PROJECT: Summerlin Village 21B Crystal Canyon Parcels A and B

CITY OF LAS VEGAS INTER-OFFICE MEMORANDUM

**DISTRICT CONCURRENCE: SUMMERLIN VILLAGE 21B CRYSTAL CANYON
PARCELS A AND B
(DS05222B) (RFCD No. 20-12480)**

Supplement to the
**TECHNICAL DRAINAGE STUDY
FOR SUMMERLIN VILLAGE 21B
PARCELS A AND B
CRYSTAL CANYON**

G-4

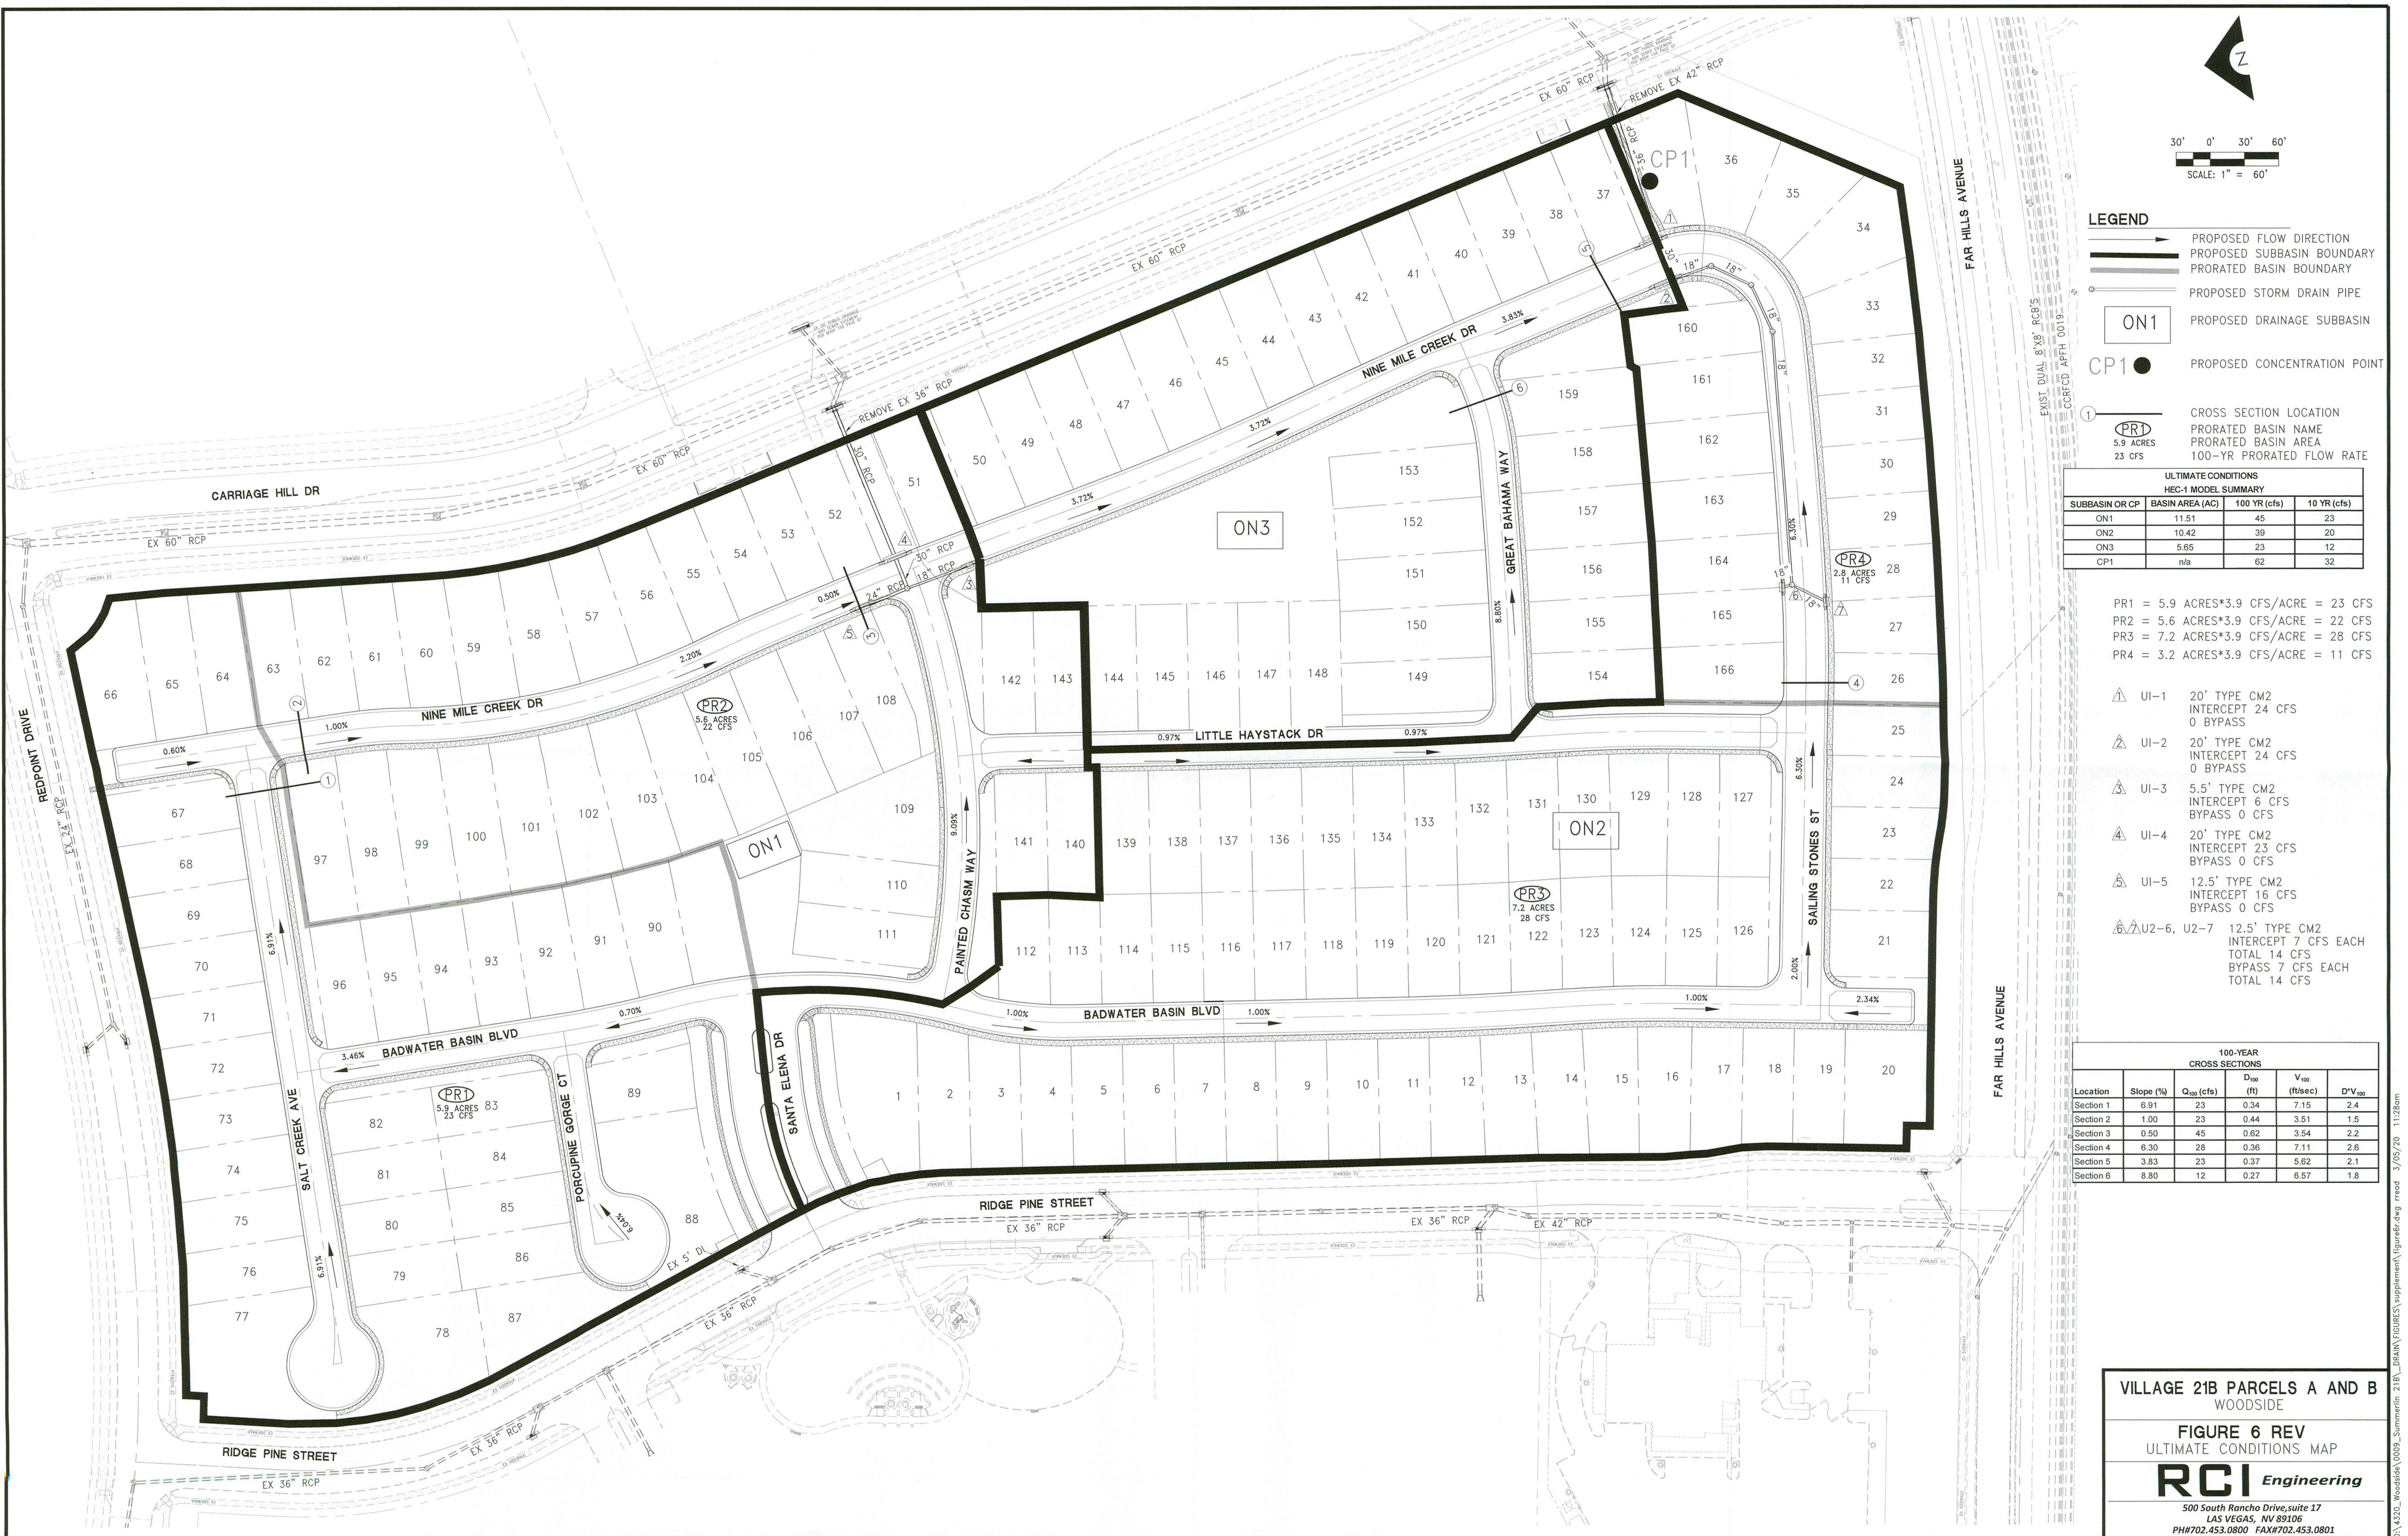
Comment 1: The maximum drop inlet length allowed in the CLV is 20'. Please revise inlet 4 to be a 20' inlet.

I finished my review of the addendum but have 1 comment that needs to be addressed before I can conditionally approve the study:
The maximum drop inlet length allowed in CLV is 20'. Please revise Inlet 4 to be a maximum of 20'. If inlets are in series, they shall be spaced a minimum of 20' apart.

Response: Drop inlet #4 has been revised to 20 feet. A revised calculation has been enclosed for that drop inlet. The calculation based on a reduced length of the inlet by 2.5 feet shows that the ponding depth at the inlet will be 0.42 feet which is still below top of curb. The previous calculation using a 22.5 foot long inlet showed a ponding depth of 0.38 and reducing the length only resulted in an increase of ponding depth of 0.04 feet. That flow is easily contained in the street and no negative impact is made by reducing that length. Sheets G-4 and P-6 from the Unit 1 improvement plans have been enclosed. Figure 6 REV was revised so that the figure shows the latest information and has been enclosed. The revised drop inlet calculation and the previous submittals calculation have also been enclosed.

20' Long Type CM2 Inlet W/2.5' Sweeper (7 Grates)

Ponding Depth = 0.42

- 23 CONSTRUCT #20 "CM2" DROP INLET PER CAAUSD #412.1,
- 24 CAAUSD #421, 7 GRATES
- 25 CALL BOX
- 26 CONSTRUCT #1 TYPE II-SD MANHOLE PER CAAUSD #405.2
- 27 CONSTRUCT SIDEWALK RAMP USING ARMOR TILE TRUNCATED
